Product Change Notice (PCN)

Subject: Assembly & sorting factory addition, assembly materials addition & change and wafer process factory addition for RL78 family LQFP package products

DIFFERENCE OF SPECIFICATION (RL78 FAMILY LQFP PRODUCTS) 10x10mm 0.65 mm pitch 52pin

MCP-AB-21-0090

10mm×10mm 0.65mm pitch 52pin LQFP Package outline (RSKL)

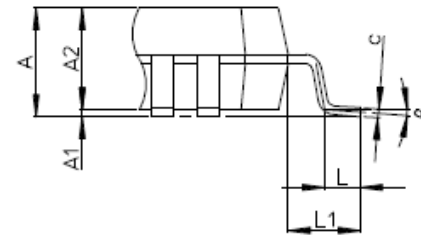
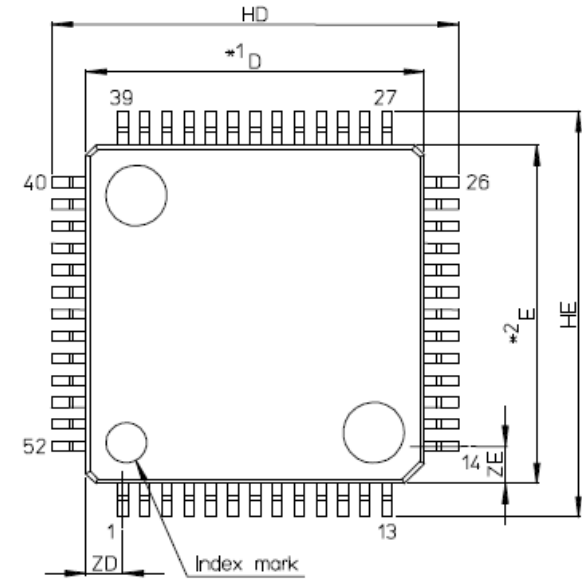
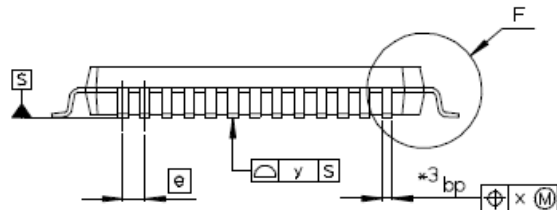
5) Package outline

There is no change in footprint for additional factory products.

Please refer to the package outline drawing and dimension comparison for the external dimensions.

Dimension comparison: 10mm×10mm 0.65mm pitch 52pin LQFP

RSKL Symbol	10x10mm 52pin LQFP PLQP0052JD-B			RSB Symbol	10x10mm 52pin LQFP PLQP0052JA-A		
	Dimension in Millimeters				Dimension in Millimeters		
	Min	Nom	Max		Min	Nom	Max
D	9.80	10.00	10.20	D	9.90	10.00	10.10
E	9.80	10.00	10.20	E	9.90	10.00	10.10
HD	11.80	12.00	12.20	HD	11.80	12.00	12.20
HE	11.80	12.00	12.20	HE	11.80	12.00	12.20
A	-	-	1.60	A	-	-	1.70
A1	0.05	0.10	0.15	A1	0.05	0.10	0.15
A2	1.35	1.40	1.45	A2	-	1.40	-
A3	-	0.25	-	-	-	-	-
b	0.25	0.32	0.40	bp	0.27	0.32	0.37
-	-	-	-	b1	-	0.30	-
c	0.10	0.145	0.20	c	0.09	0.145	0.20
-	-	-	-	c1	-	0.125	-
L	-	0.50	-	L	0.35	0.50	0.65
Lp	0.45	0.60	0.75	-	-	-	-
L1	0.80	1.00	1.20	L1	-	1.00	-
θ	0°	3°	8°	θ	0°	-	8°
e	-	0.65	-	e	-	0.65	-
x	-	0.13	-	x	-	-	0.13
y	-	0.10	-	y	-	-	0.10
ZD	-	1.10	-	ZD	-	1.10	-
ZE	-	1.10	-	ZE	-	1.10	-

Marking visibility

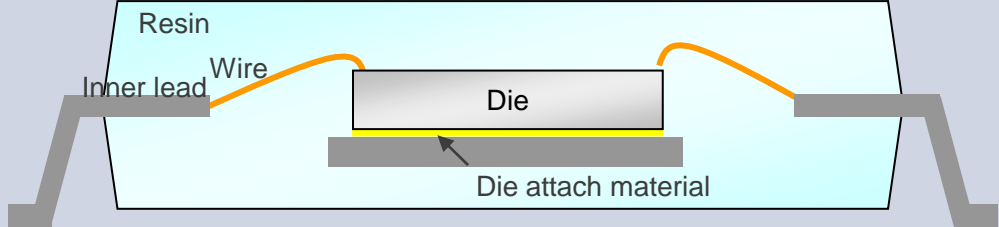
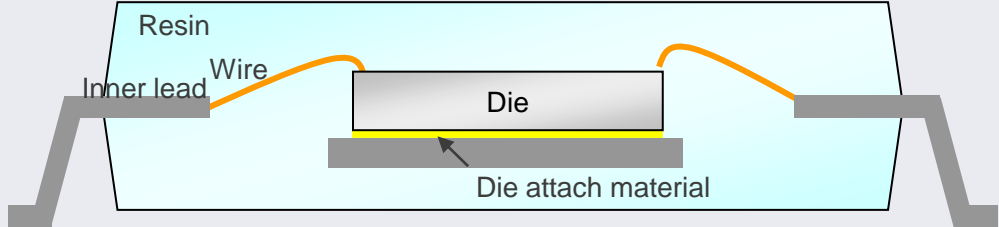
6) Marking

Change the marking font and specification.

Product	RSKL (Additional factory)	RSB (Existing factory)
Blank products		
	1st row 9 characters: product name 2nd row - 3rd row 9 characters: Lot №	1st row - 2nd row 9 characters: product name 3rd row 7 characters: Lot №
ROM products		
	1st row 8 characters: product name 2nd row 3 characters: ROM code 3rd row 9 characters: Lot №	1st row 3 characters: ROM code 2nd row 8 characters: product name 3rd row 7 characters: Lot №
